Harton State

## SUNDRY NOTICES AND REPORTS ON WELLS

Proposed Plugging Procedures  
Stearns  
Harton State #2  
30-025-27505

Action 213935

Harton State #2  
API 30-025-27505  
WBD Before PA

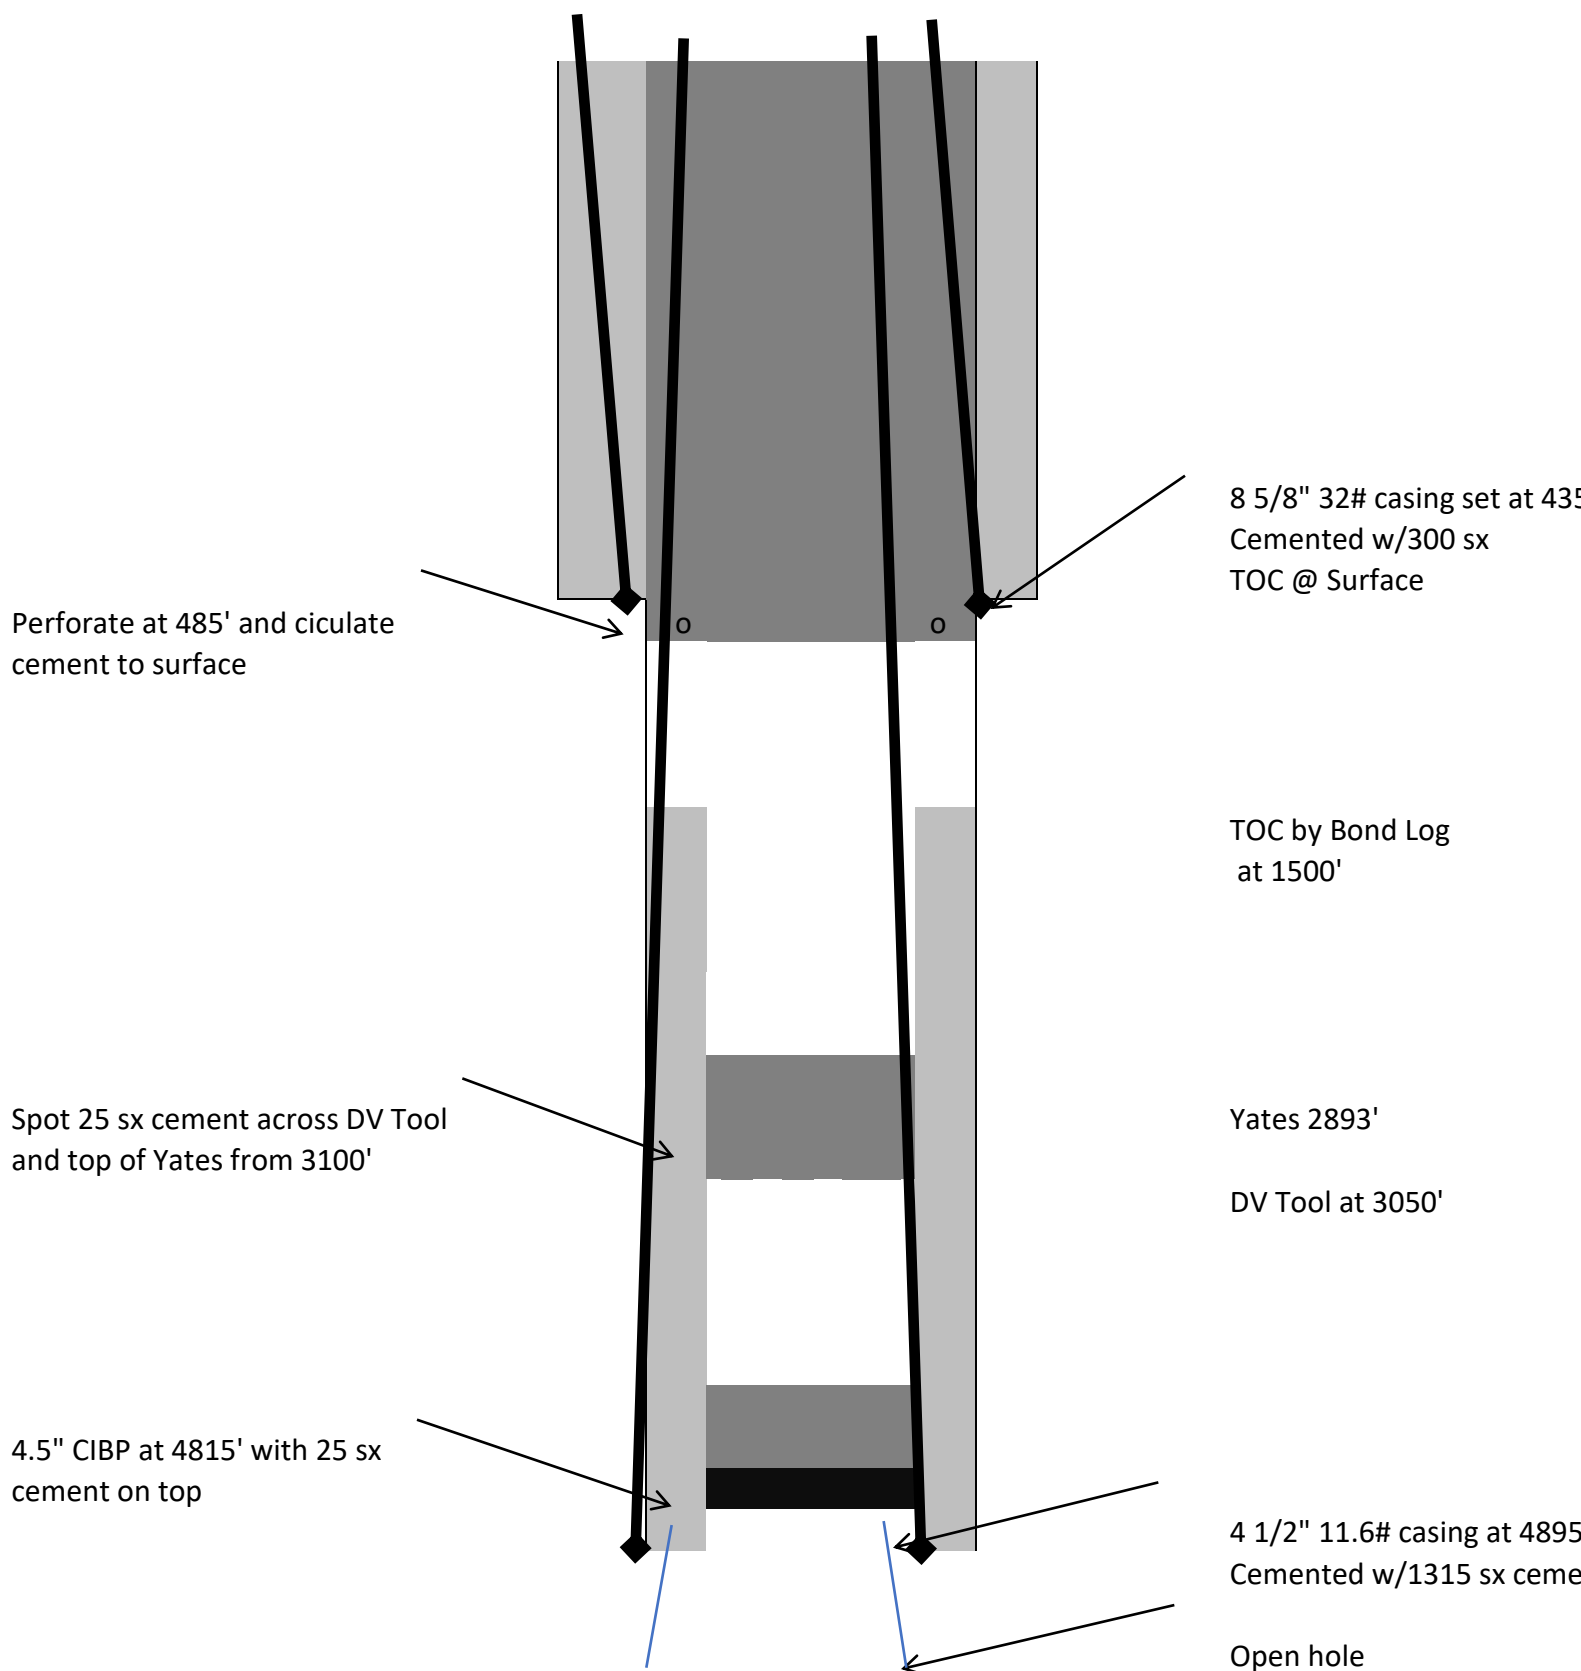
LPC area Below ground marker take photo before backfilling
